## **AER RESPONSES**

Frontier Project - Response to Supplemental Information Request: Round 3 - AER

**Figure 3a-1: Corehole Locations**

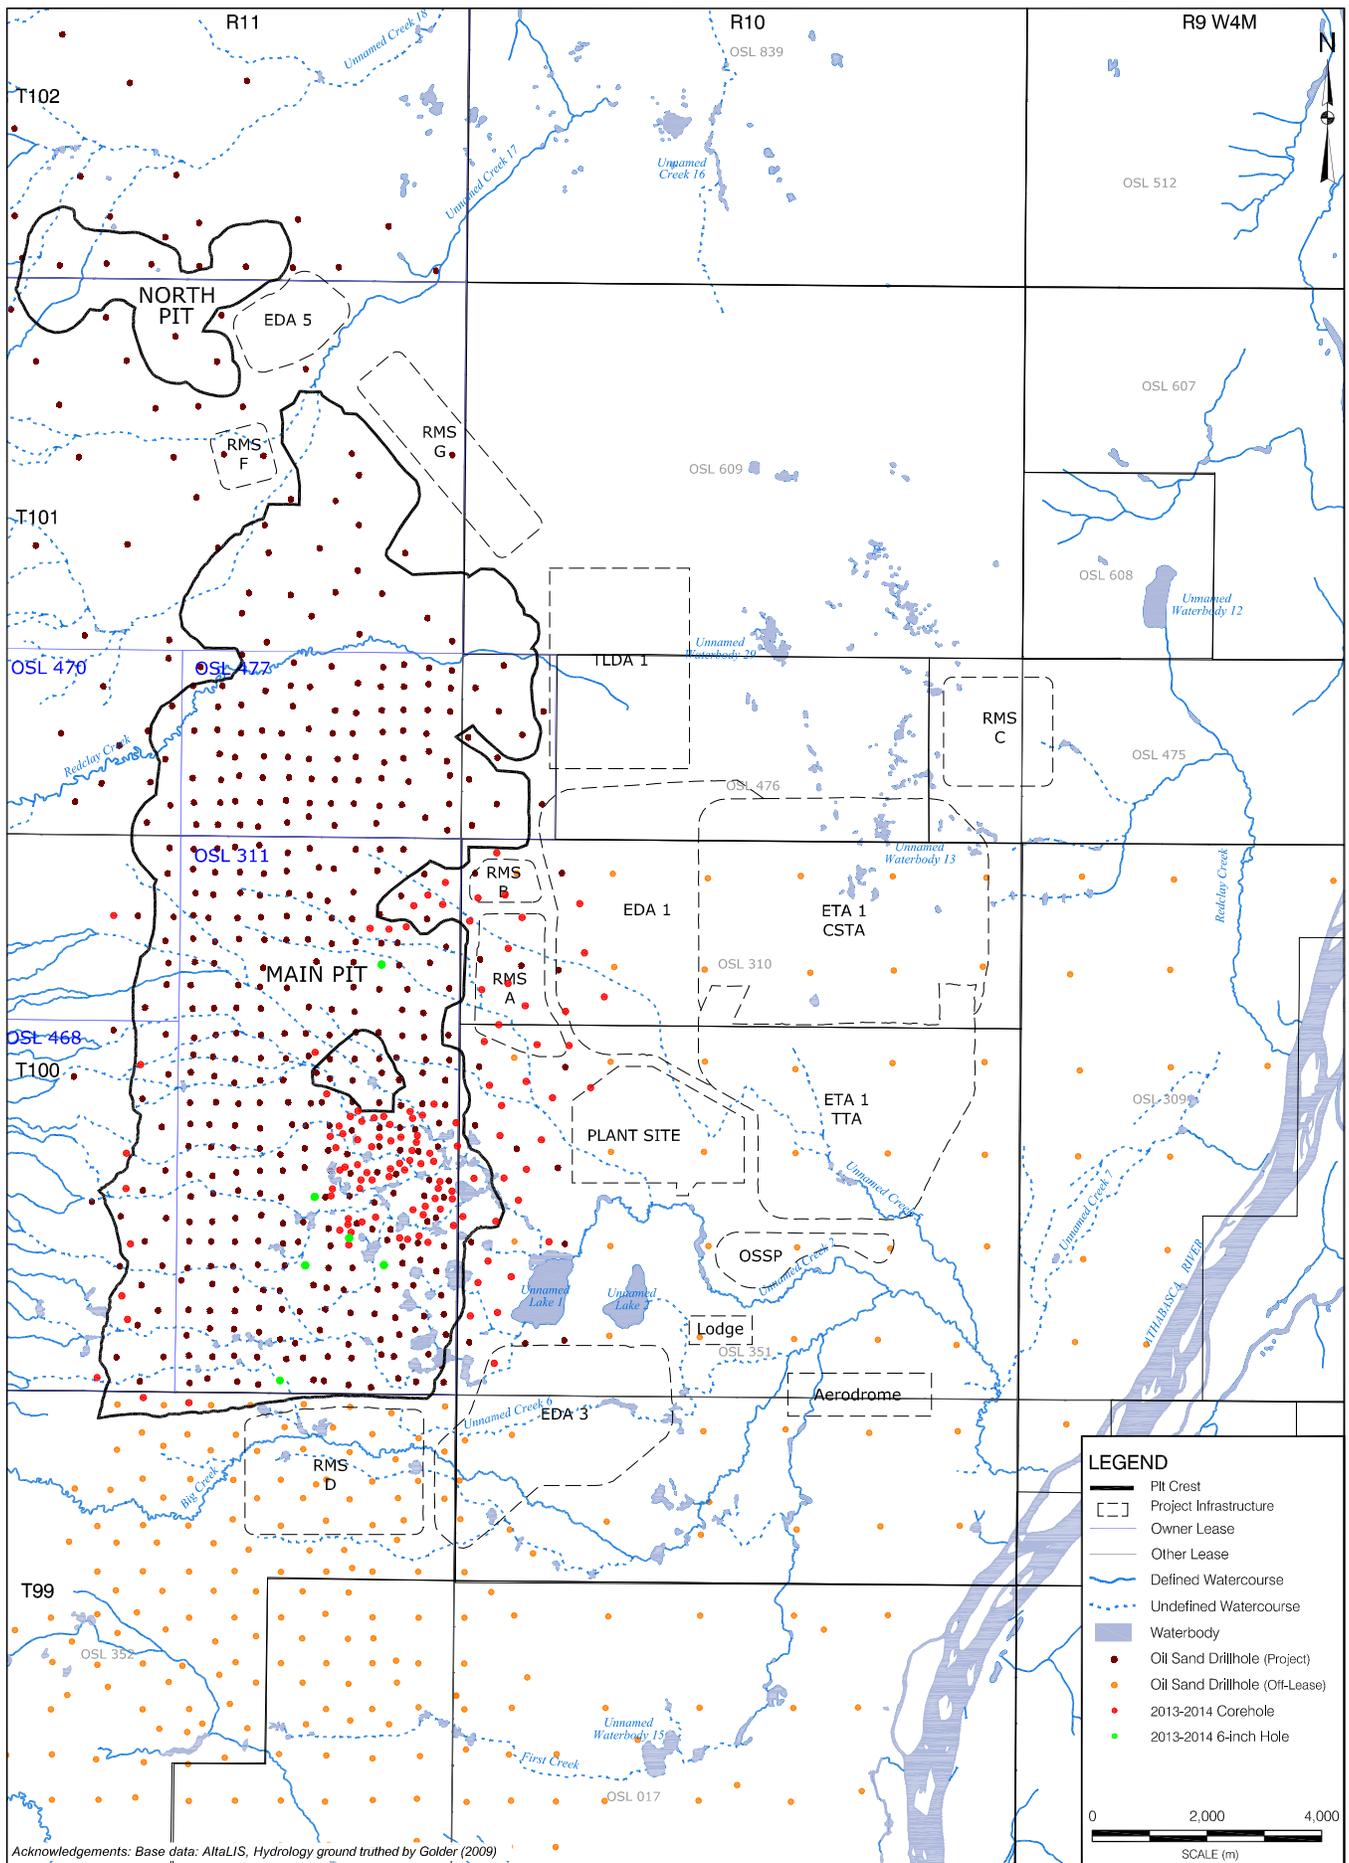
**Provide an update on drilling, including**

- a) a core hole location map, showing actual and planned drilling, in .DXF format, and
- b) any core hole data not previously submitted to the AER. Core hole data must be submitted in accordance with the table and codes provided in SIR No. 1, Appendix 1, and in .XLS or .CSV format.

For a map showing the locations of coreholes completed during the 2014 drilling program, see Figure 3a-1. An electronic DXF file is provided in Appendix 3a.1.

**Figure 6a-1 Material Balance for Average Grade Ore, Phases 1 to 3 Combined – Stream-Day (Revised Figure 53a-2)**

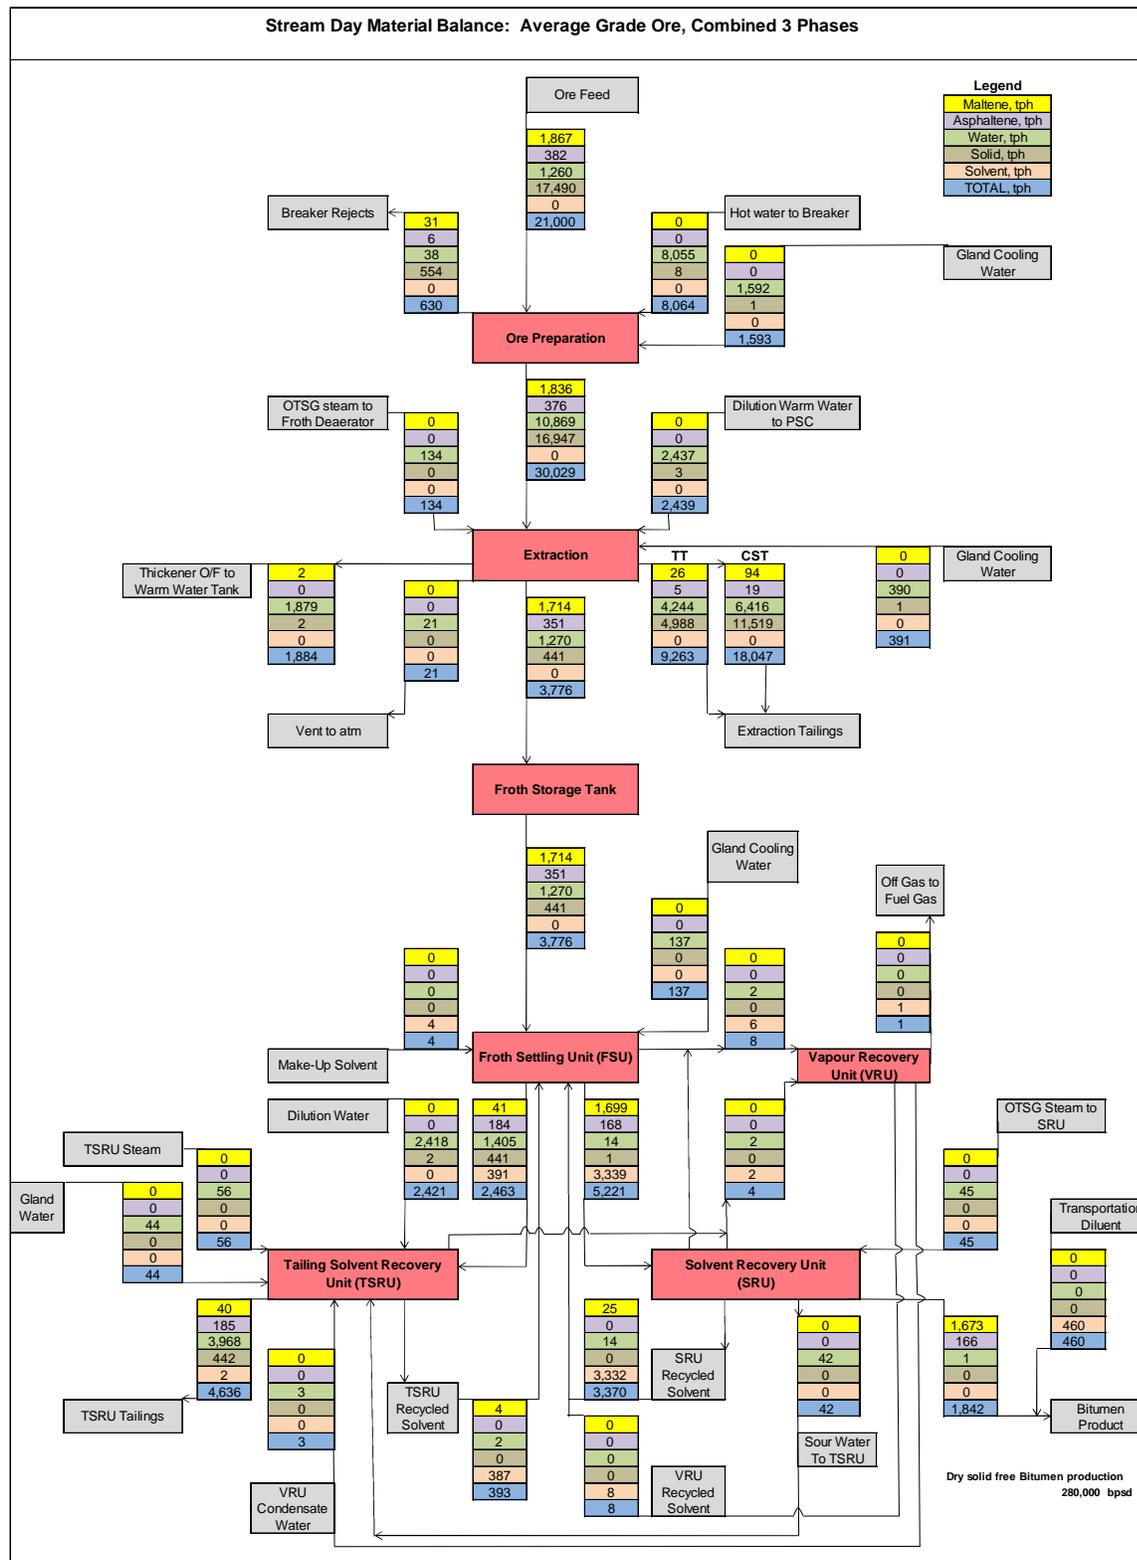
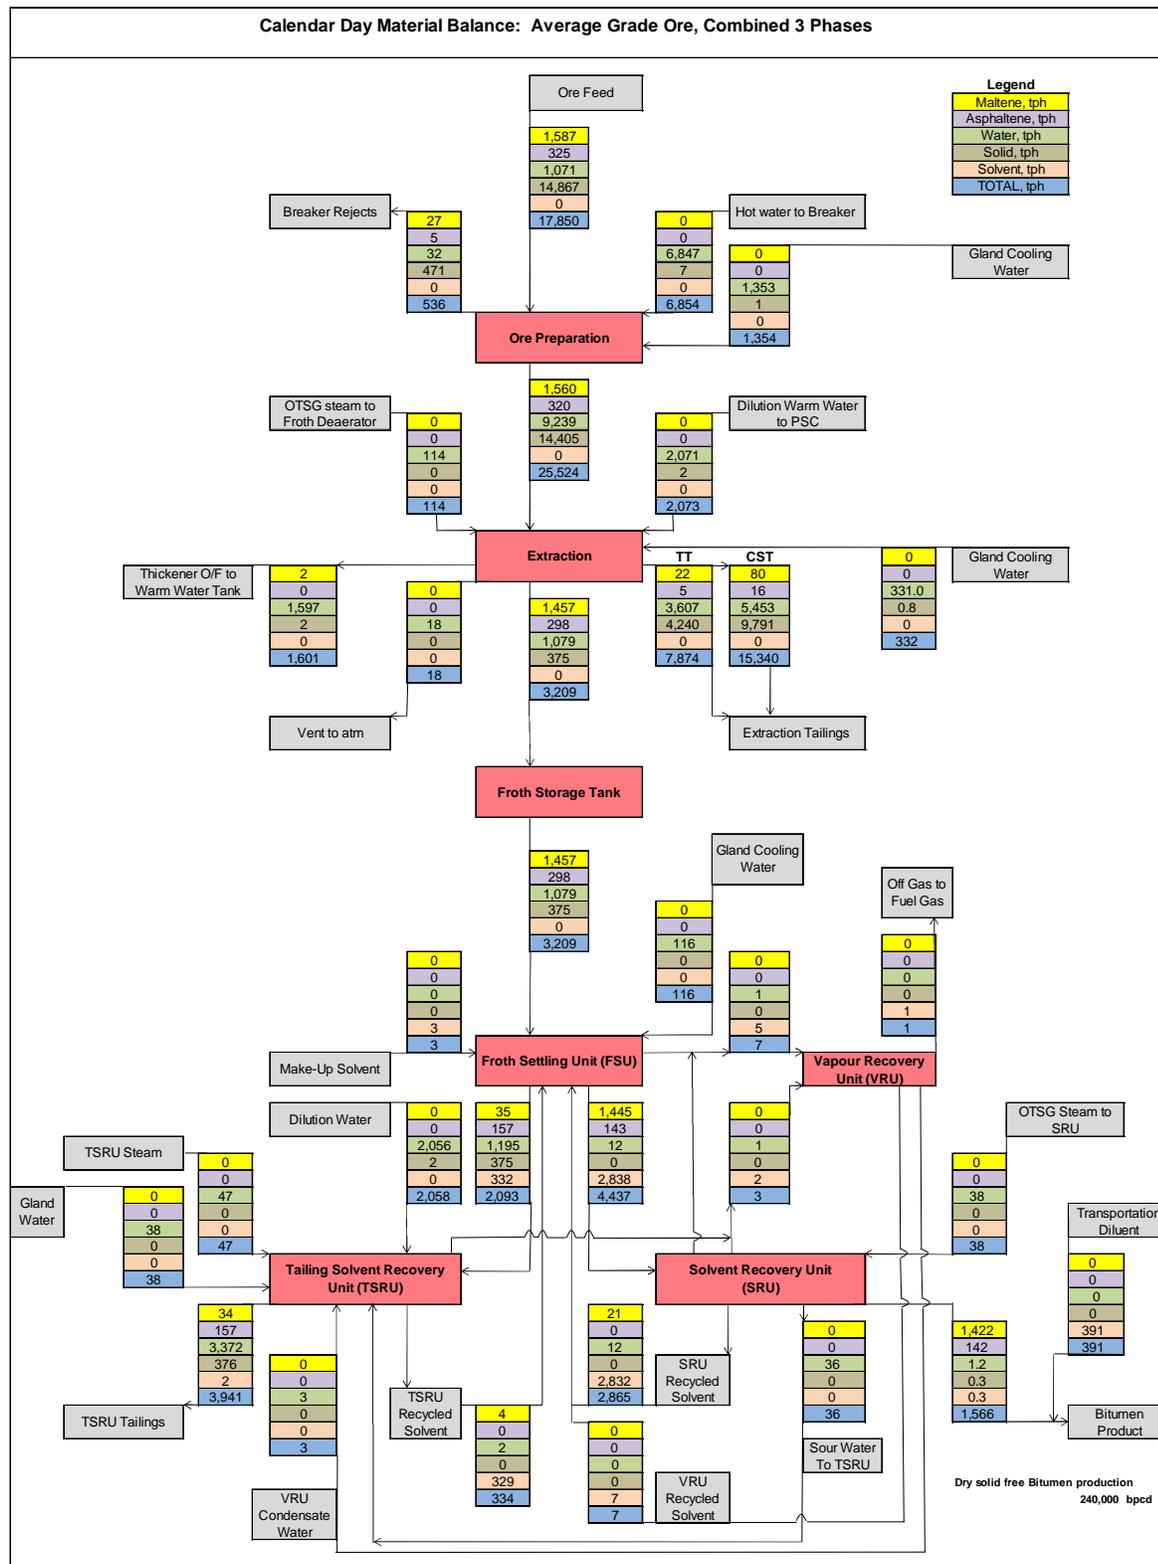
**SIR2 Response, ERCB Response 17, Page 45. Teck states, “With the removal of the SDA from the Project (see ERCB Round 2 SIR 1), the overall Project mass balance changes.”**

**a) Provide an updated SIR1, Volume 1, Response 53, Figures 53a-1 and 53a-2, Pages 103 and 104, which includes SIR2 Response, ERCB Response 18, Figure 18a-1, Page 47.**

a) Revised material (mass) balances are provided for average-grade ore during average winter-summer conditions. Figures 6a-1 and 6a-2 show the updated material balances per stream day and calendar day, respectively, and represent Phases 1 to 3 combined. Phase 4 is no longer included because of the Teck–Shell asset exchange described in ERCB Round 2 SIR 1. The material balance for the vapour recovery unit (VRU) has also been updated.

**Figure 8a-1 Updated Tailings Management Strategy**

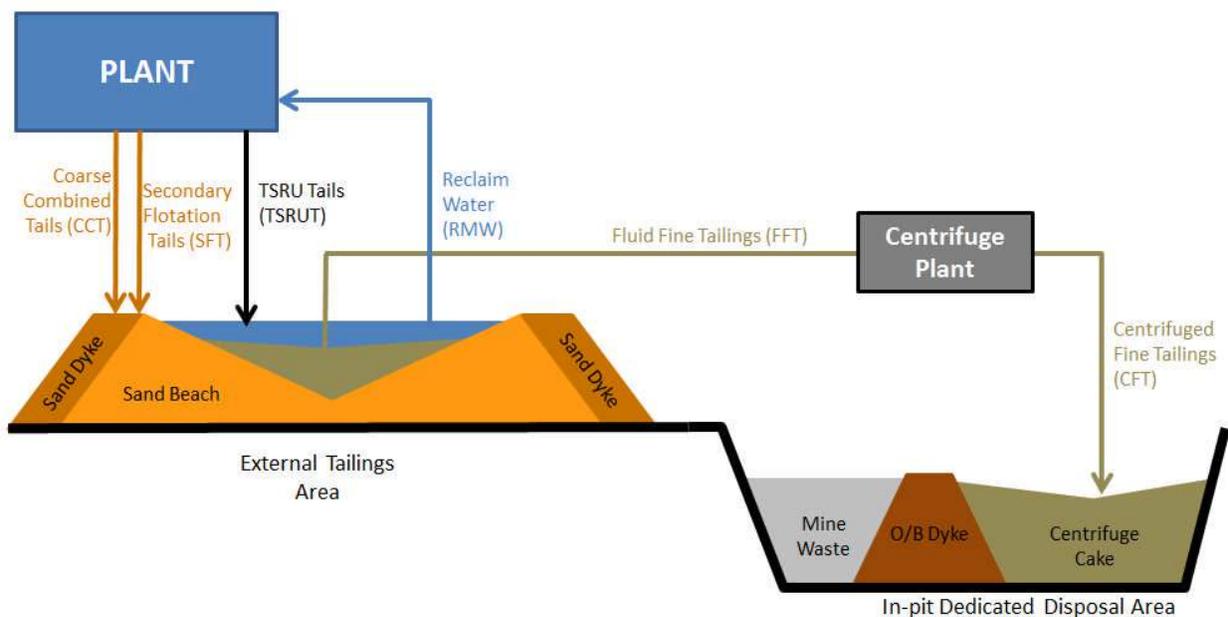
**SIR2 Response, ERCB Response 21, Page 50. Teck states, “It is assumed that the TT deposit. . .will meet the intent of the strength criteria identified in *Directive 074*.” Figure 21a-1, Page 51 shows that the expected solids content of the TT deposit will be 60wt% about two and half years after deposition, and 68 wt% at the end of the 12-year deposition cycle. Based on existing tailings management knowledge, TT deposits with less than 60 wt% solids are not expected to achieve the undrained shear strength of 5 kPa within one year of deposition, as required by *Directive 074*.**

The tailings management strategy developed for the Integrated Application was based on engineering completed in 2009 and 2010. Since then, Teck’s understanding of tailings management options has improved because of additional processability testing and knowledge gained through membership in COSIA. This has allowed Teck to improve the tailings management plan for the Project. Instead of producing thickened tailings using a thickener and thin lift drying to consolidate mature fine tailings, which would be trucked to EDAs, the updated strategy involves depositing coarse combined tailings (CCT) through dyke construction and beaching. Dykes will be constructed using CCT, forming a tailings area that will collect fluids and contain other tailings streams including secondary flotation tailings (SFT) and tailings solvent recovery unit tailings (TSRU).

tailings management strategy for the Project, see Figure 8a-1. Overall, the updated strategy is superior to that presented in the Integrated Application because

Additional information about the tailings management strategy will be provided as part of the Project Update as engineering advances. However, consistent with the response to ERCB Round 2 SIR 21, Teck believes that the updated tailings deposition scheme will meet the intent of *Directive 074* in achieving a trafficable landscape that facilitates progressive reclamation. Although the overall tailings management plan is improved, processed fines are unlikely to achieve 5 kPa one year after deposition. However, the strength gain over time will support capping of the in-pit DDAs prior to mine closure and the post-closure landscape will fully meet the intent of the directive.
